<b>Title - Sujet</b> Construction Services	
<b>Solicitation No. - N° de l'invitation</b> EW038-200761/A	<b>Amendment No. - N° modif.</b> 002
<b>Client Reference No. - N° de référence du client</b> PSPC-EW038-200761	<b>Date</b> 2019-08-19
<b>GETS Reference No. - N° de référence de SEAG</b> PW-\$PWU-023-11653	
<b>File No. - N° de dossier</b> PWU-9-42055 (023)	<b>CCC No./N° CCC - FMS No./N° VME</b>
<b>Solicitation Closes - L'invitation prend fin</b> <b>at - à 02:00 PM</b> <b>on - le 2019-08-27</b>	<b>Time Zone</b> <b>Fuseau horaire</b> Mountain Daylight Saving Time MDT
<b>F.O.B. - F.A.B.</b> <b>Plant-Usine:</b> <input type="checkbox"/> <b>Destination:</b> <input type="checkbox"/> <b>Other-Autre:</b> <input type="checkbox"/>	
<b>Address Enquiries to: - Adresser toutes questions à:</b> Taylor (RPC), Ian	<b>Buyer Id - Id de l'acheteur</b> pwu023
<b>Telephone No. - N° de téléphone</b> (780) 566-9487 ( )	<b>FAX No. - N° de FAX</b> (780) 497-3510

## ADDENDUM No. 2

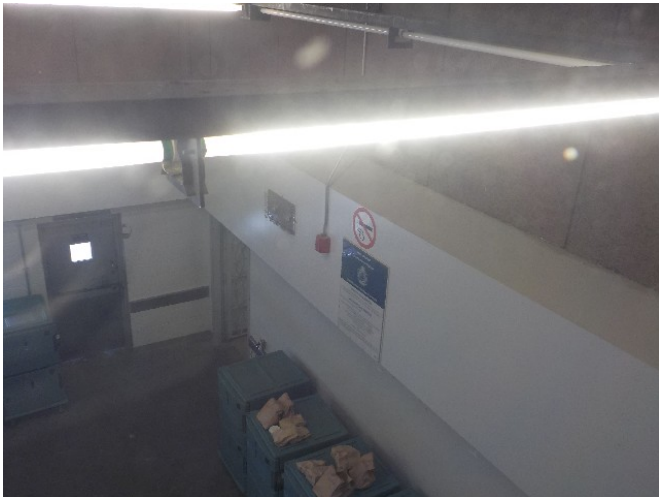
2.3	<p><b>Question:</b> There are flammable wall panels that are currently around the area in the Kitchen where Window #65 is located. There is a risk of this material burning when in contact with oxidizers or ignition sources. Is this material to remain?</p> <p><b>Answer:</b> <i>Ensure that surrounding areas where welding takes place that areas of construction are properly protected / covered as required to execute work. Refer to image below for reference.</i></p> <div data-bbox="319 1348 974 1841"></div>
